URGENT - Field Safety Notice ***TraumaDiagnost***

Check of integrity for Trauma Arm

FSN MA FCO-72000015 April 2020

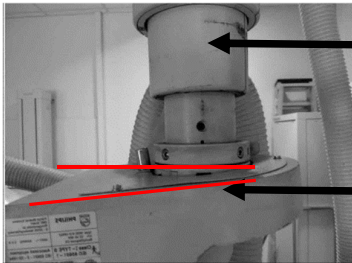
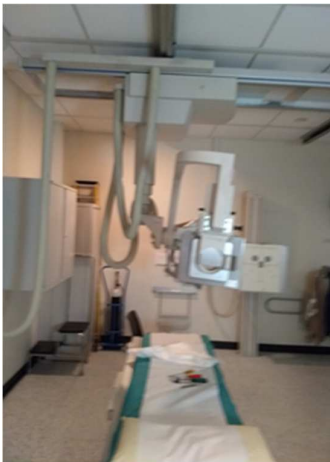
AFFECTED PRODUCTS	All TraumaDiagnost
PROBLEM DESCRIPTION	<p>A trauma arm is a U-shaped carrier of tube assembly and cassette holder, which are therefore always centered for easy positioning with trauma patients. It allows the operator to make all relevant diagnostic projections without moving the patient.</p> <p>The Trauma arm is connected to the telescopic column of the ceiling suspension by a shaft, which is fixed to a supporting block. If the shaft breaks, the trauma arm can fall down.</p>
HAZARD INVOLVED	<p>There is the potential for a serious injury if one of the following occurs:</p> <ul style="list-style-type: none">• Fatigue fracture (crack) of the shaft• Crack increases during lifetime without being noticed by the operator or service engineer (unusual angle of Trauma arm)• Shaft breaks• Person located nearby falling trauma arm

HOW TO IDENTIFY AFFECTED PRODUCTS	<p>An operator noticed an unusual angle of the trauma arm with respect to the telescopic column of the ceiling suspension.</p> <div style="display: flex; align-items: center;">  <div style="margin-left: 10px;"> <p>Telescopic column of ceiling suspension</p> <p>Supporting block</p> </div> </div> 
ACTION TO BE TAKEN BY CUSTOMER / USER	<p>The IfU (Instruction for Use) require the operator to not use the system and call for service, if a mechanical defect or malfunction is suspected. As soon as a deformation is determined, the system may no longer be used and call the service engineer. Should you feel uncertain regarding these instructions, please contact Philips.</p>
ACTIONS PLANNED BY PHILIPS	<p>The affected systems will be get an onsite check of the status of the Trauma arm for deformations as shown on the pictures.</p>
FURTHER INFORMATION AND SUPPORT	<p>If you would like any further information or support concerning this issue, please contact your local Philips representative:</p> <p>0800 80 3000</p>
